IEEE 802.11
Wireless Access Method and Physical Layer Specifications

Title: **Proposed Updates to the D1.1 Draft,
Sections 2, 3, 4 & 5 -- Security (WEP)**

Abstract: **This paper proposes changes to the D1.1 Draft to reflect the resolution
of comments made during the May 95 meeting.**

doc: IEEE P802.11-95/095

Figure 2-11, Portion of the ISO Basic Reference Model Covered in this Standard

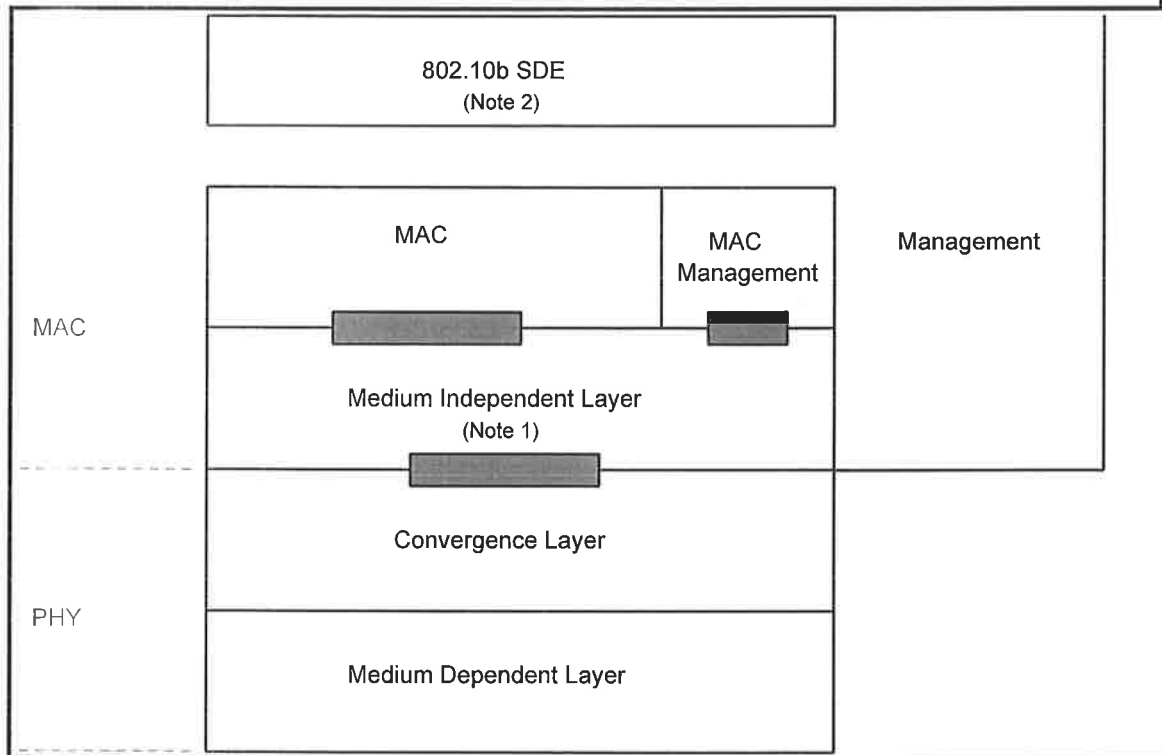
<< editors please remove the box labeled "802.10b SDE in the followign figure - we did not have MSDRAW avail to do the edit - db>>

>>> editor note - the interface shown in the above figure between MAC and Phy was supposed to have been removed as part of the April LB votes. Please correct the figure to remove this interface. <<<

Figure 5-24: Construction of expanded WEP MSDUSDE_PDU

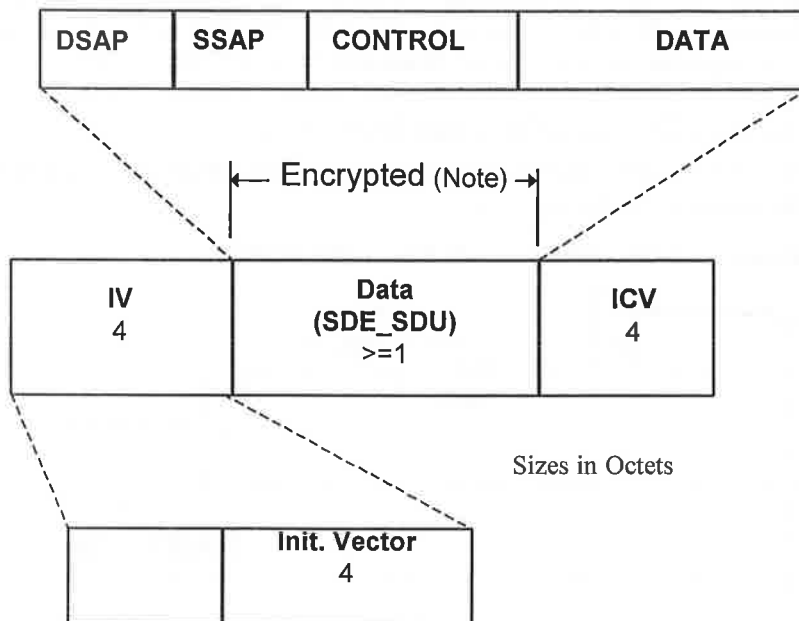
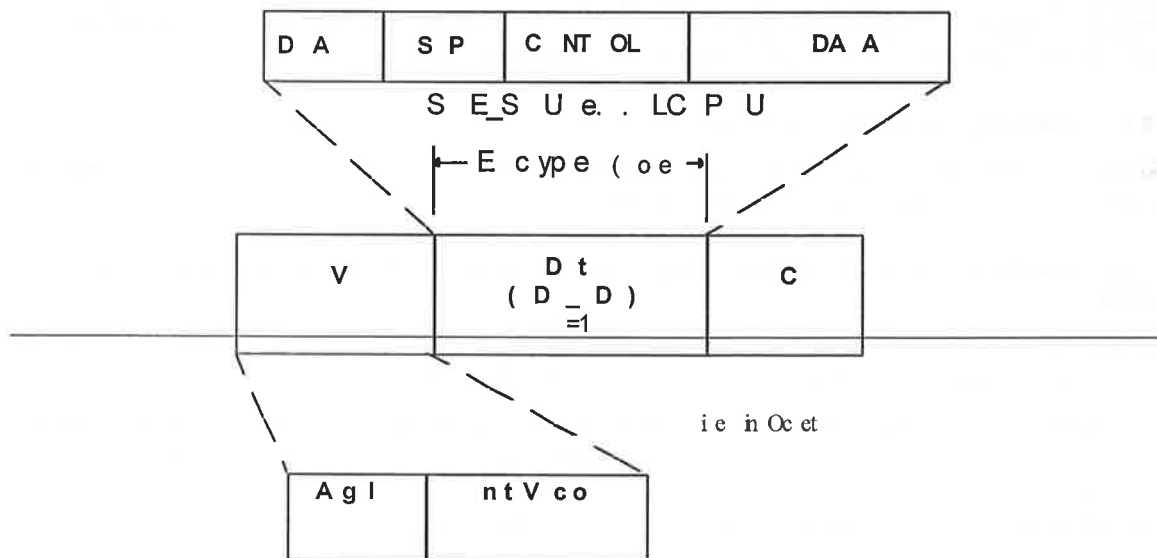
The 802.10 WEP mechanism is invisible to entities outside the 802.11 MAC. allows for 802.10 SDE entities to be operating in the same protocol stack. If a user chooses to deploy an SDE environment that requires SDE settings more comprehensive than those in the WEP subset, and/or based on an encryption algorithm not supported for the WEP function, that user may disable the WEP function, thereby avoiding the overhead of performing twice on the same MSDU. This is consistent with the 802.10 model, in which lower layer SDE entities are generally disabled when higher layer SDE entities are present.

Note: The encipherment process has expanded the original MSDU by 8 Octets, 4 for the Initialization Vector (IV) field and 4 for the Integrity Check Value (ICV). The ICV is calculated on the Data field only.

Note: The encipherment process has expanded the SDE_SDU by 8 Octets, 4 for the initialization vector (IV) field and 4 for the integrity check value (ICV). The ICV is calculated on the Data field only.
